Purchasing Services

RE: **ADDENDUM #2**
8565-0-2016-BP
Structural Engineering Consultant

Elevation View of Sawtooth Roof.
PV on south slope
Skylight on north slope

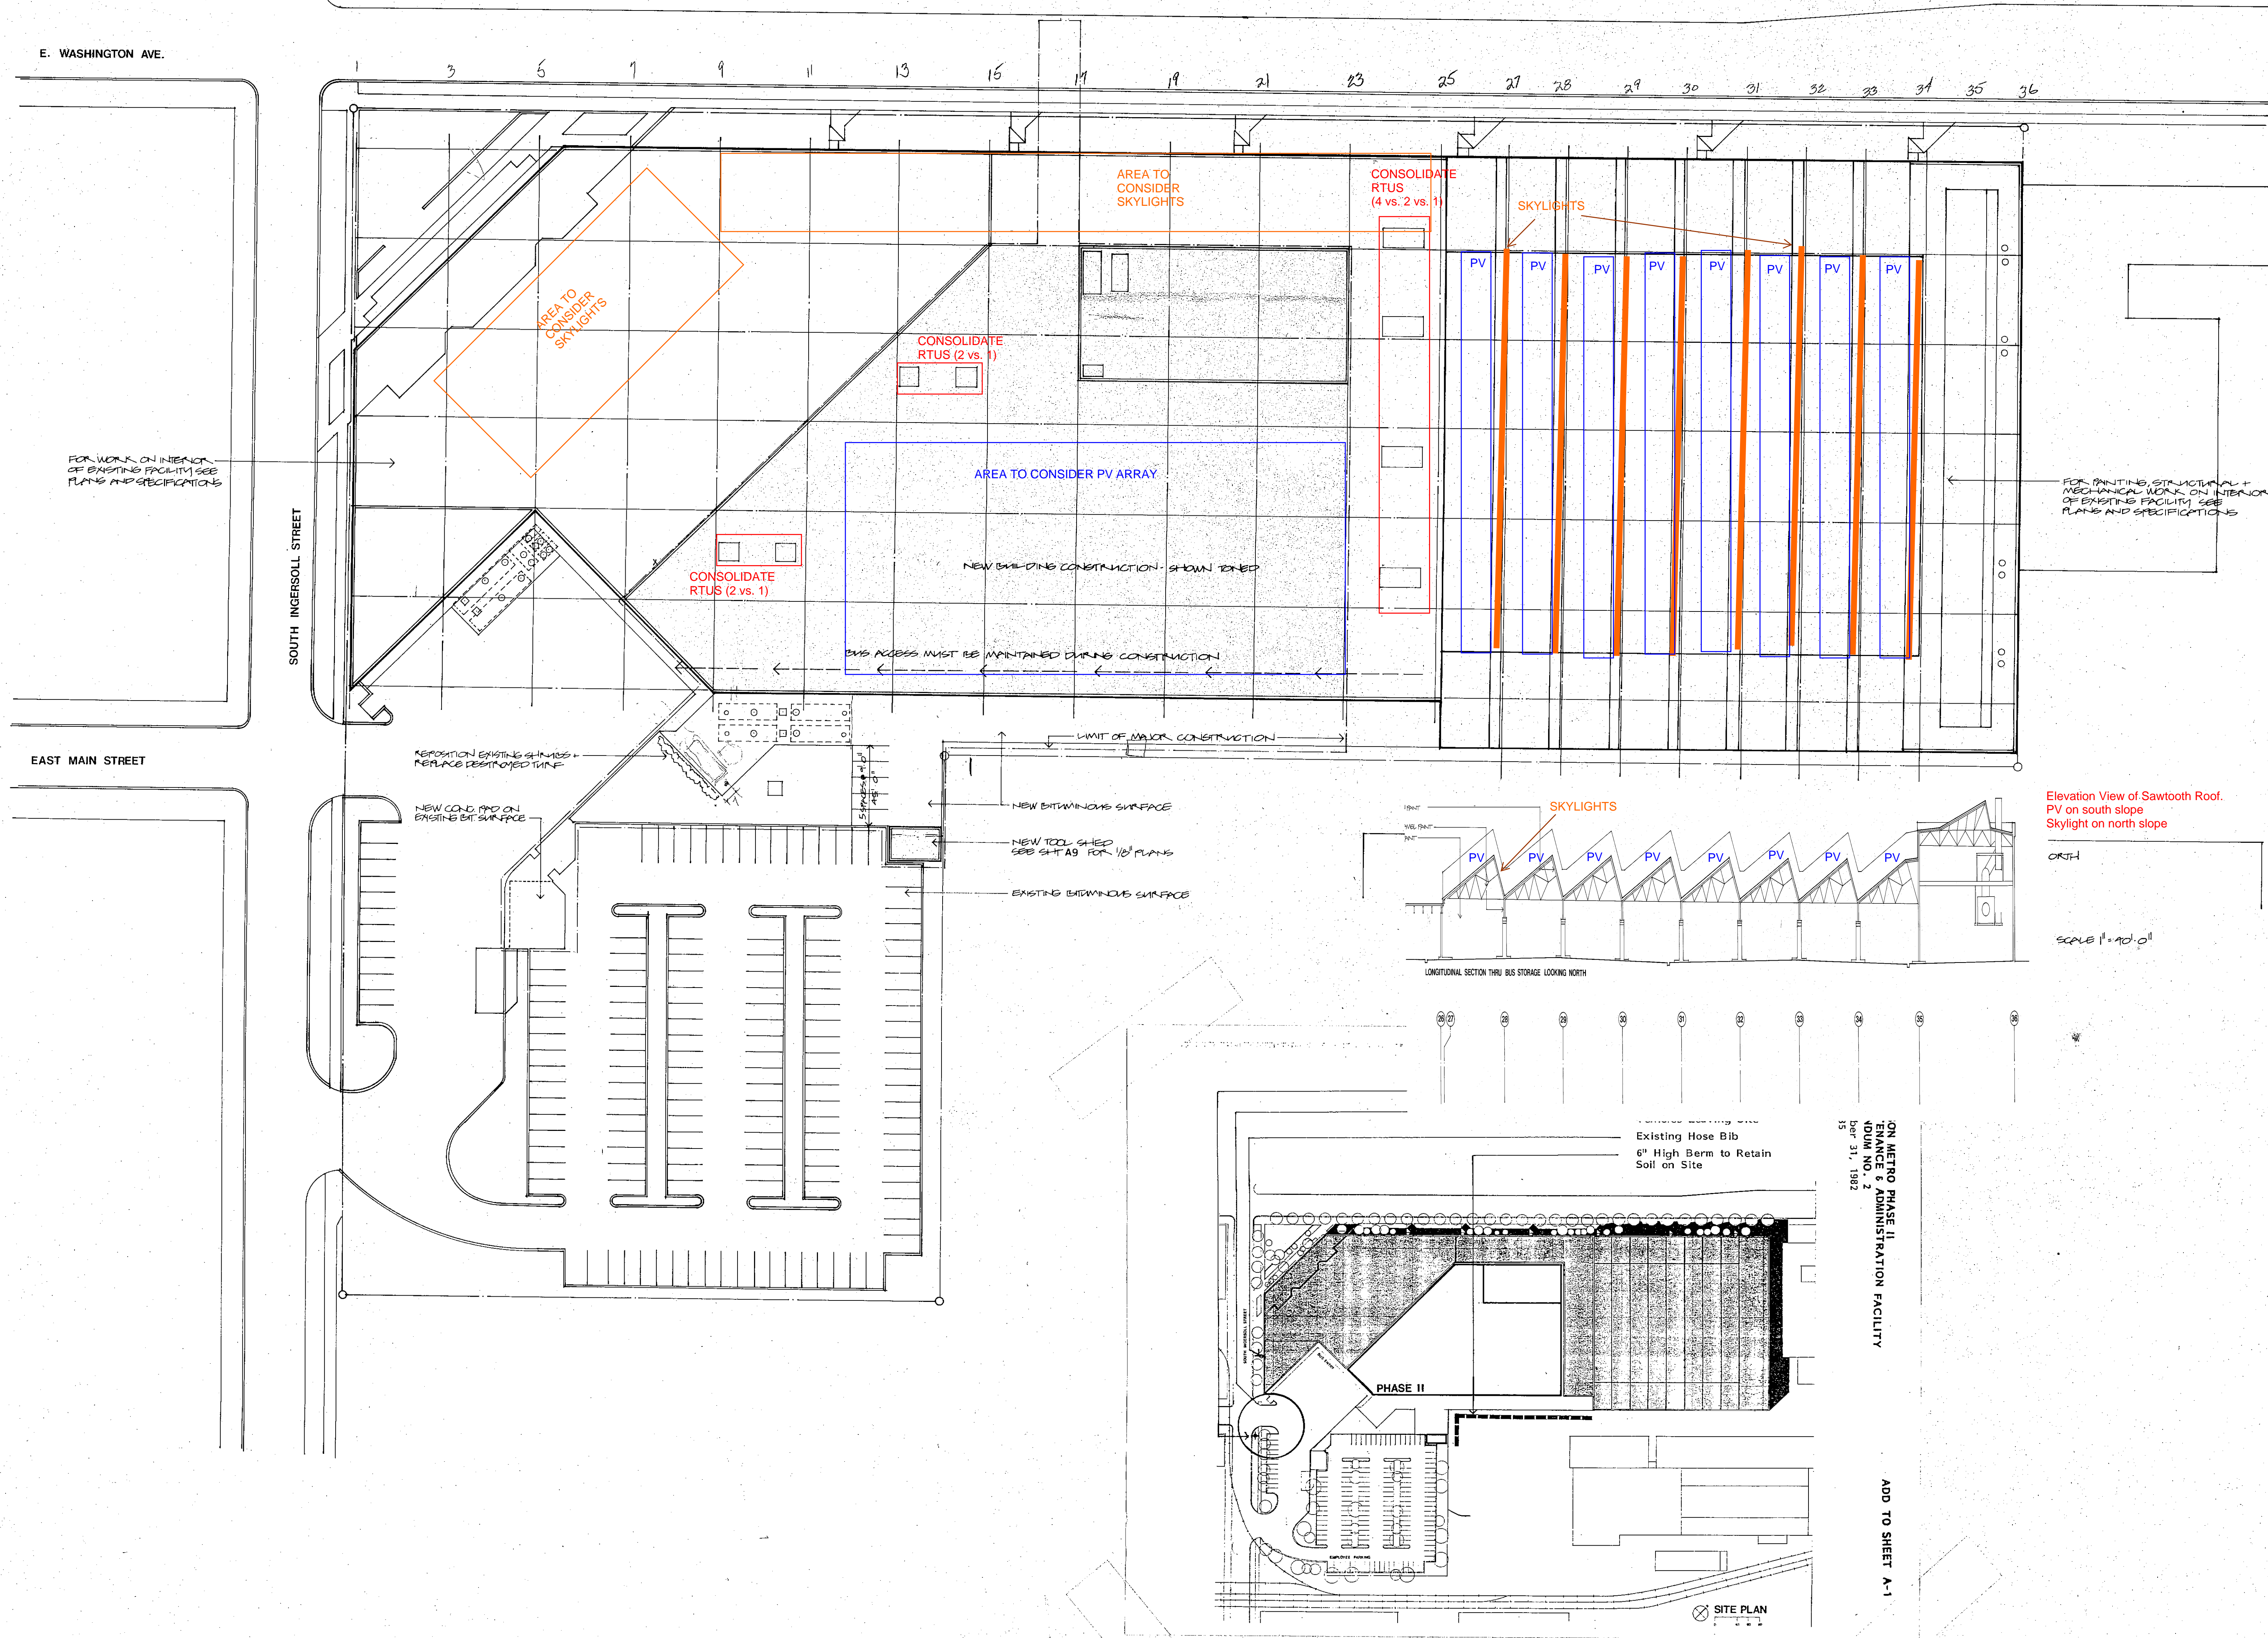
14) Could you identify areas on the roof that you are considering for PV, skylights or rooftop unit modifications?

A) See attached roof plan identifying these areas.
